City of South Bend PLAN COMMISSION

AGENDA

Monday, May 19, 2025 - 4:00 P.M.

Proposed Plat

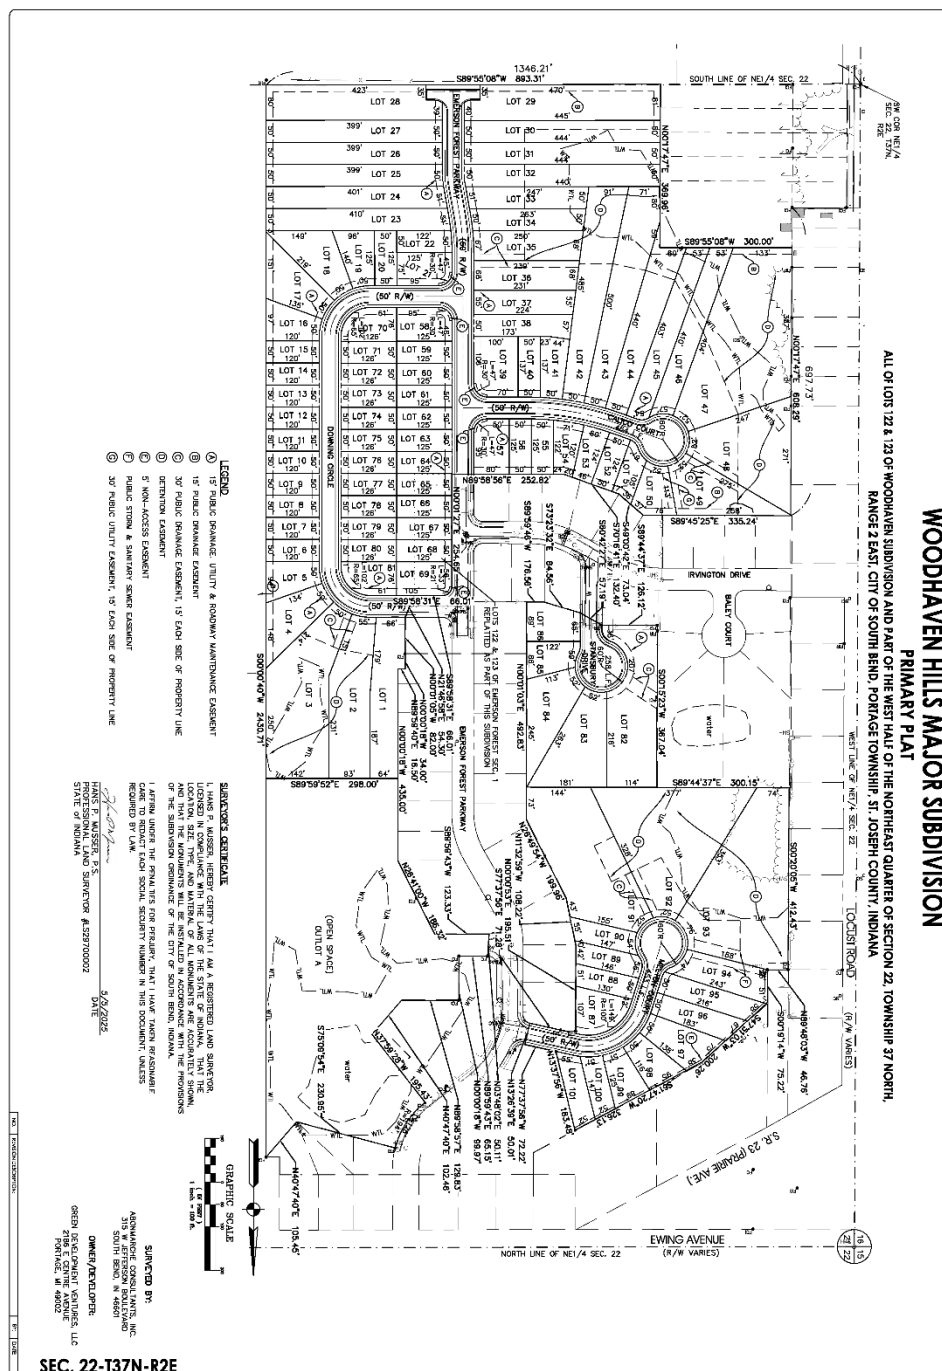
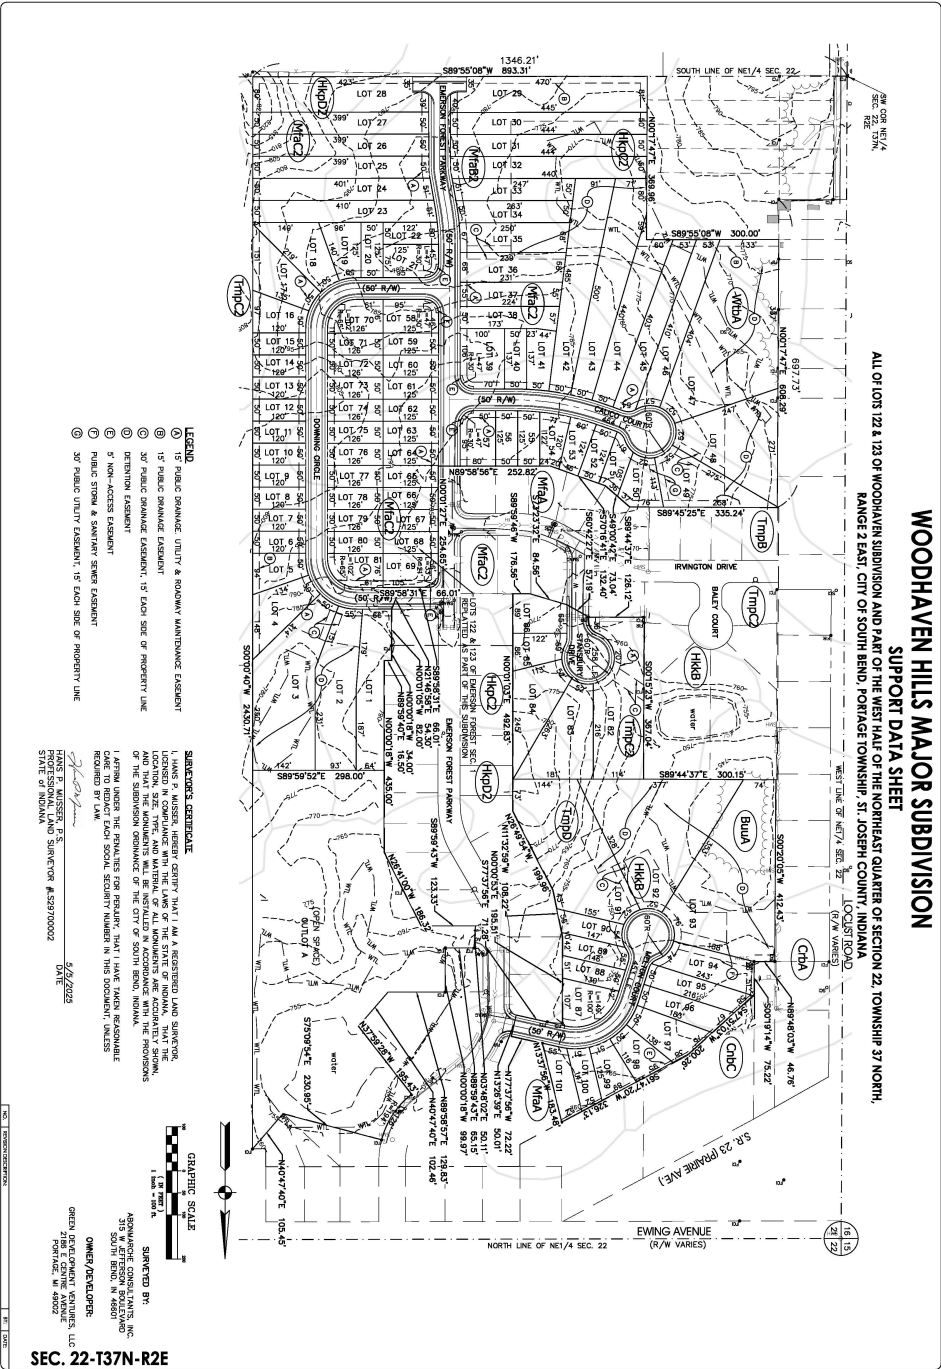
Environmental Data:	A check of the Agency's maps indicates that no environmental hazard areas or wetlands are present.
Drainage:	
Rights-Of-Way:	The rights-of-way are correct as shown.
Utilities:	The site will be served by Municipal Water and Municipal Sewer.
Agency Comments:	Sewer and water will need to be extended with a service agreement with BPW in the secondary plat process. SDC will be required and will be a part of the sewer and water agreement BPW utility extension agreement is required prior to subdivision recording.

Staff Comments: The registered surveyor on behalf of the property owner requests the following waivers from the Subdivision Control Ordinance: Section 21-11.04 (b)(6) Cul-de-sac and dead-end streets, designed to be so permanently, shall not be longer than 200 feet measured along its centerline from the centerline of the intersecting street to the radius point. The waiver is justified in response to the existing layout of streets, significant topography, and wetland areas that limit the potential for street connectivity.

Staff Recommendation: The Staff has reviewed this subdivision and finds that if the waivers are granted and the conditions are met, it complies with the requirements for Primary Approval as specified by the South Bend Subdivision Control Ordinance. The Staff therefore recommends that this subdivision be granted Primary Approval, subject to the following: Adding a deed of dedication to the primary plat; updating Outlot A to Lot 102 with an "open space easement" to define property responsibility for the open space.

Proposed Plat

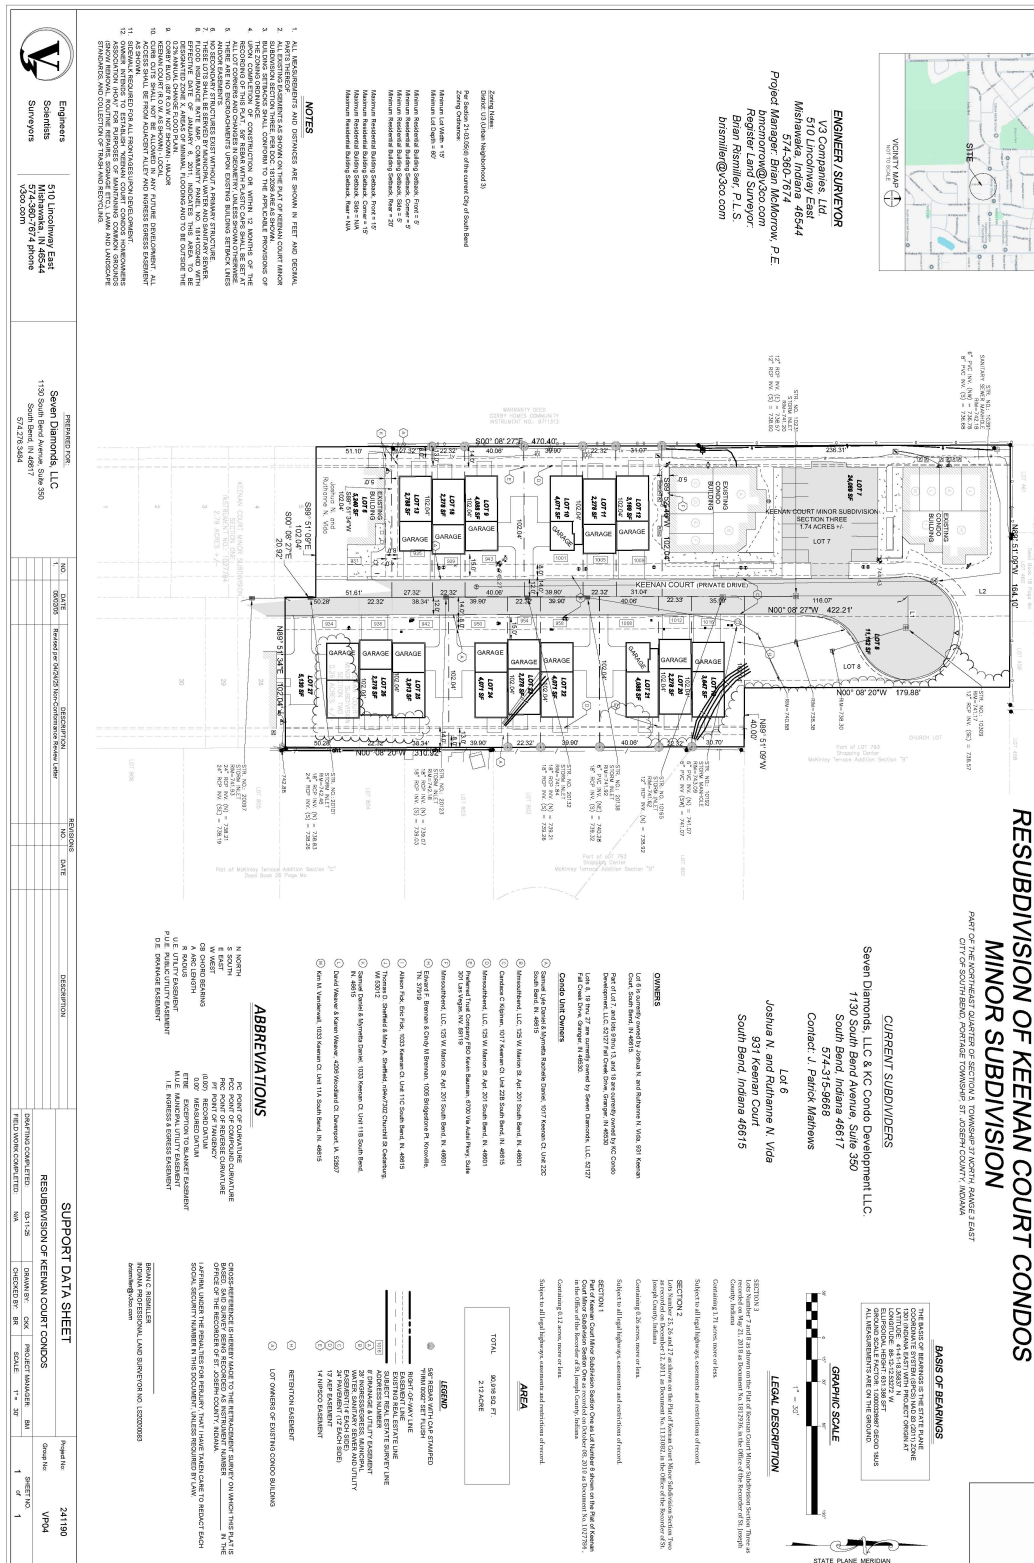
Environmental Data:	A check of the Agency's maps indicates that no environmental hazard areas or wetlands are present.
Drainage:	
Rights-Of-Way:	The rights-of-way are correct as shown.
Utilities:	The site will be served by Municipal Water and Municipal Sewer.
Agency Comments:	Please provide drainage calculations showing existing infrastructure meets current standards. An agreement may be necessary if the water and sewer need to be dedicated as public.

Staff Comments: Please change “Current Subdividers” to “Subdividers.”

Staff Recommendation: The Staff has reviewed this subdivision and finds that if the conditions are met, it complies with the requirements for Primary Approval as specified by the South Bend Subdivision Control Ordinance. The Staff therefore recommends that this subdivision be granted Primary Approval, subject to the following: Making the necessary agreements if water and sewer need to be dedicated to the public and drainage calculations show that existing infrastructure meets current standards.

Proposed Plat

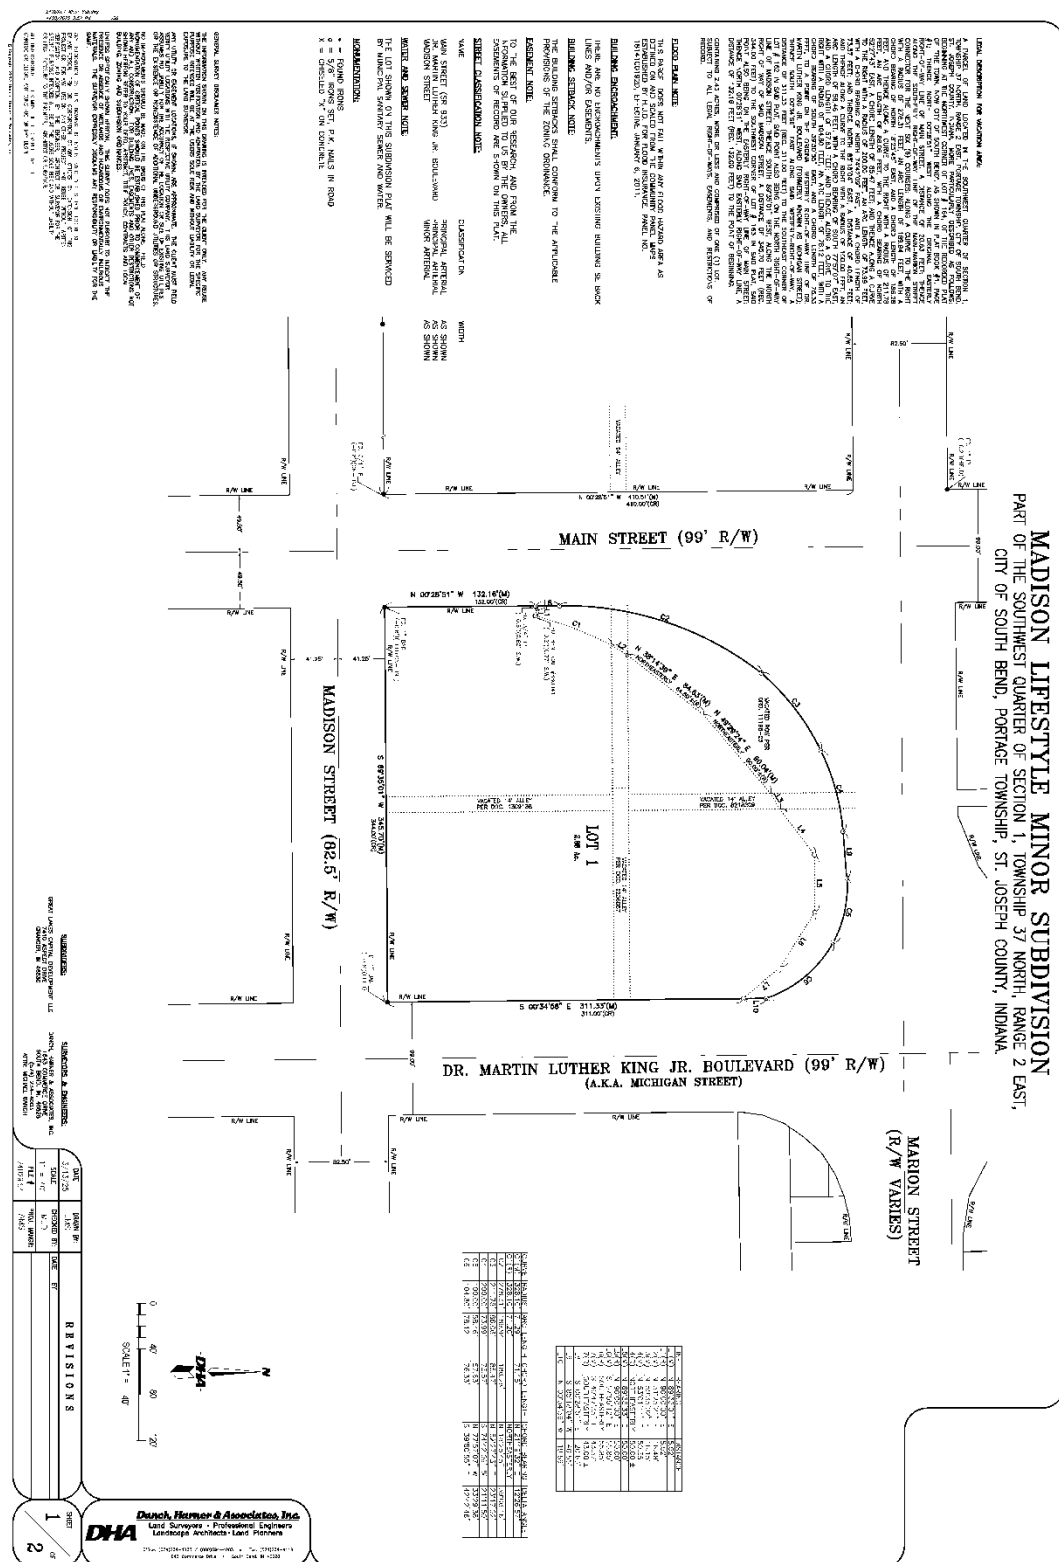
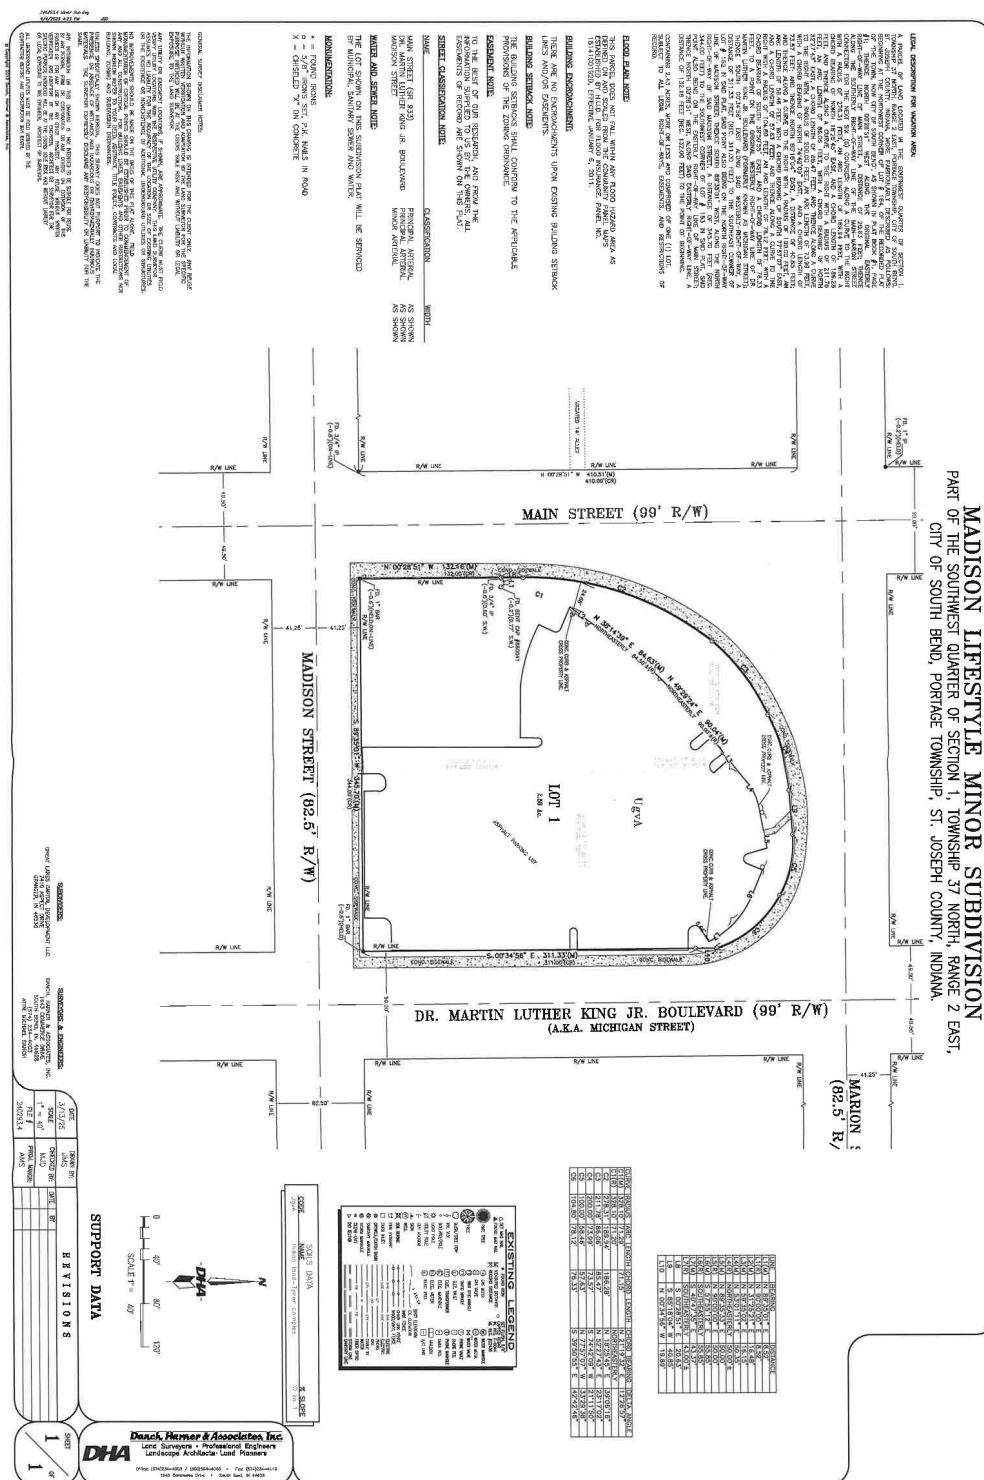
Environmental Data:	A check of the Agency's maps indicates that no environmental hazard areas or wetlands are present.
Drainage:	A drainage plan will be required for any development.
Rights-Of-Way:	The rights-of-way are correct as shown.
Utilities:	The site will be served by Municipal Water and Municipal Sewer.

Staff Comments: A drainage plan will be required for any development.

Staff Recommendation: The Staff has reviewed this subdivision and finds that if the conditions are met, it complies with the requirements for Primary Approval as specified by the South Bend Subdivision Control Ordinance. The Staff therefore recommends that this subdivision be granted Primary Approval, subject to the following: the street names being correctly identified.
